HISTORIC AND DESIGN REVIEW COMMISSION

November 04, 2020

HDRC CASE NO: 2020-390
COMMON NAME: Dawson at N Olive (three individual lots, currently unaddressed)
LEGAL DESCRIPTION: NCB 570 (OLIVE-DAWSON SUBD), BLOCK 6 LOT 23
NCB 570 (OLIVE-DAWSON SUBD), BLOCK 6 LOT 22
NCB 570 (OLIVE-DAWSON SUBD), BLOCK 6 LOT 21
ZONING: RM-4, H
CITY COUNCIL DIST.: 2
DISTRICT: Dignowity Hill Historic District
APPLICANT: Ron Alvarado/AG Associates Architects
OWNER: Douglas Miller/DM Dirt, LLC
TYPE OF WORK: Construction of three, 2-story residential structures
APPLICATION RECEIVED: August 31, 2020
60-DAY REVIEW: Not applicable due to City Council Emergency Orders
CASE MANAGER: Edward Hall

The applicant is requesting conceptual approval to construct three, 2-story residential structures on the vacant lot at the corner of Dawson at N Olive, located within the Dignowity Hill Historic District. These lots are currently unaddressed.

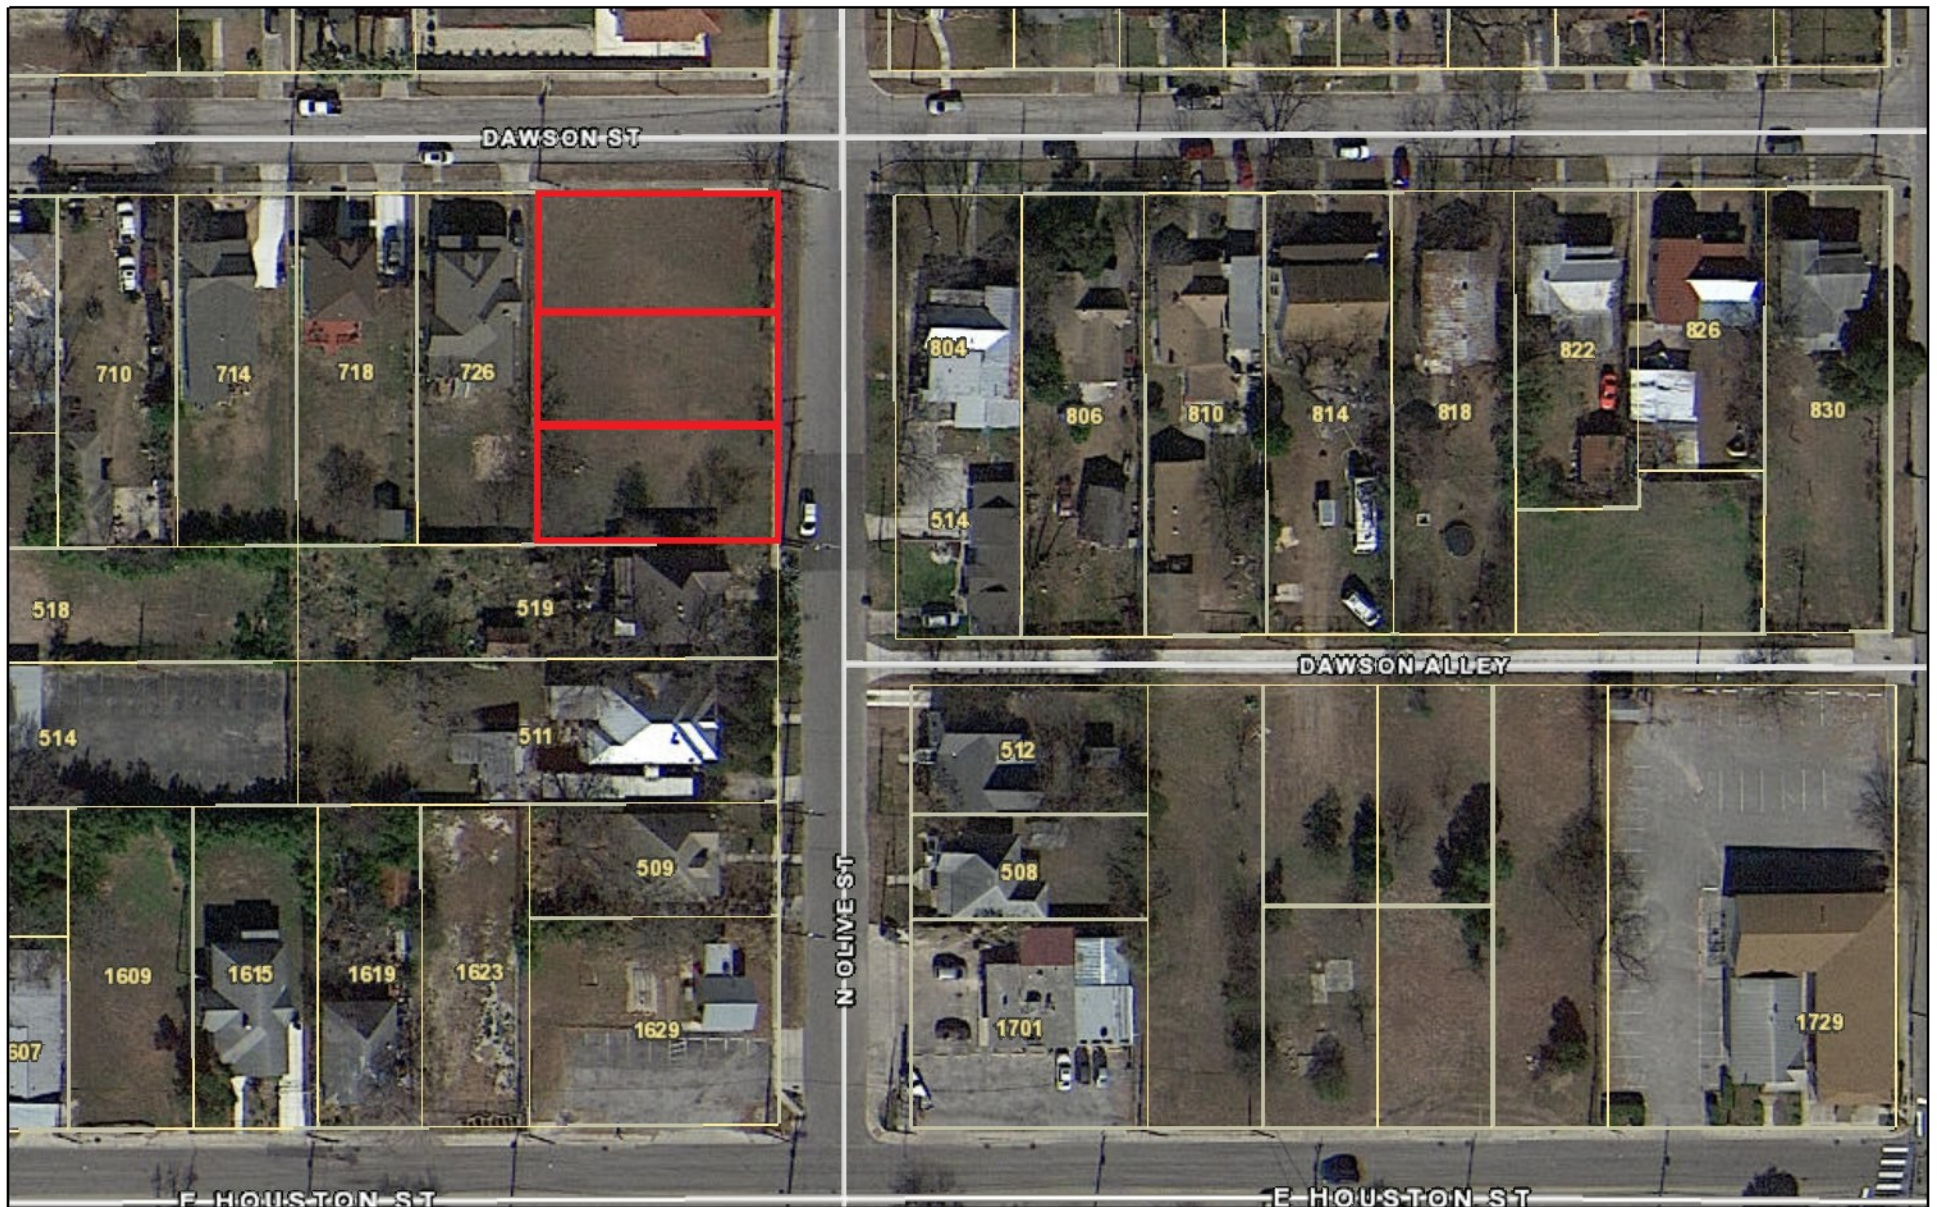
- h. **SETBACKS & ORIENTATION** – The applicant has proposed for the new construction to feature setbacks that are generally equal to those found historically on both Dawson and N Olive. Regarding orientation, as noted in finding c, houses found historically on Dawson Street on corner lots feature an orientation toward Dawson. The proposed orientation toward N Olive is inconsistent with the Guidelines and historic development pattern found within the district. Staff finds that multiple structures should be re-oriented toward Dawson. Additionally, staff finds that setbacks that are greater than those found historically would be most appropriate. Increased setbacks may potentially reduce the perceived massing as it is currently proposed.

OVERALL SITE PLAN -

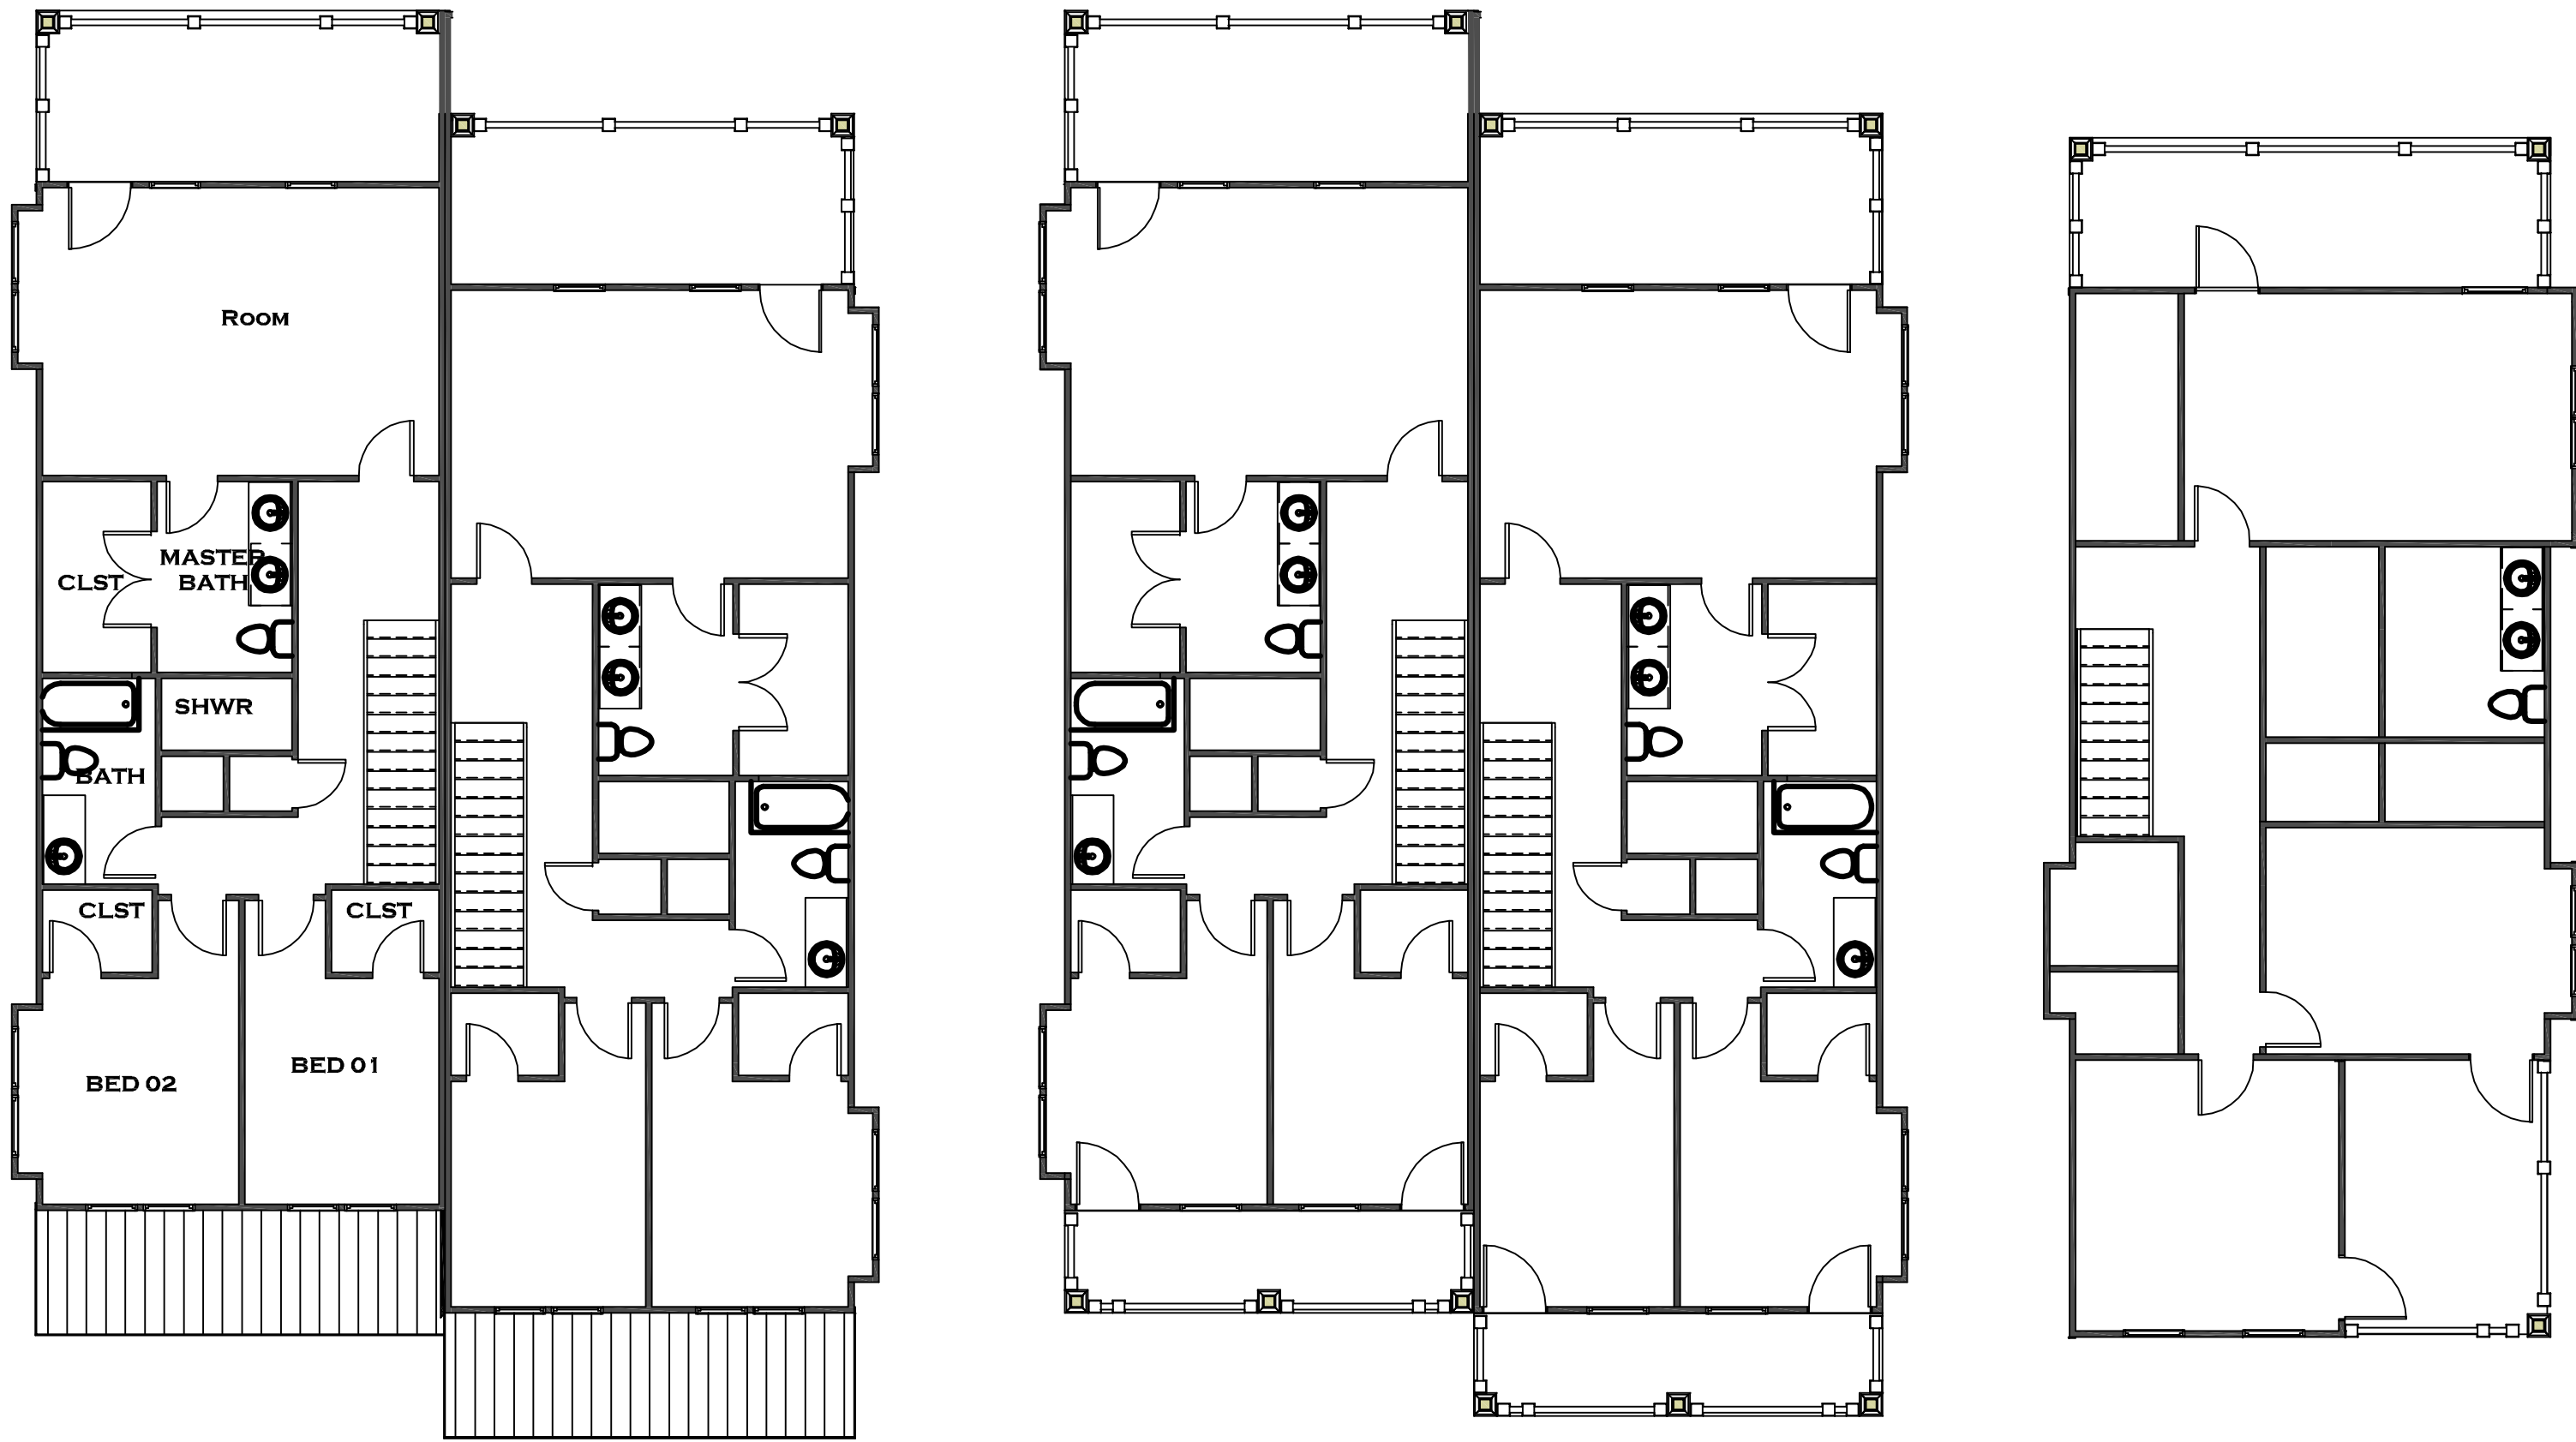
- i. That the entire site plan be reconfigured to allow for multiple buildings to be oriented toward Dawson as noted in finding h.
- ii. That the applicant incorporate a reduced massing and height as noted in finding i. As proposed, the massing is atypical for what is found historically within the district. The height of new construction should not exceed the height of adjacent historic houses by more than one story. Additional height may be accomplished through a change in roof form, utilization of a half-story, or step downs in height from adjacent single story homes.

13'6" +/-

20'-0" +/-
SET BACK
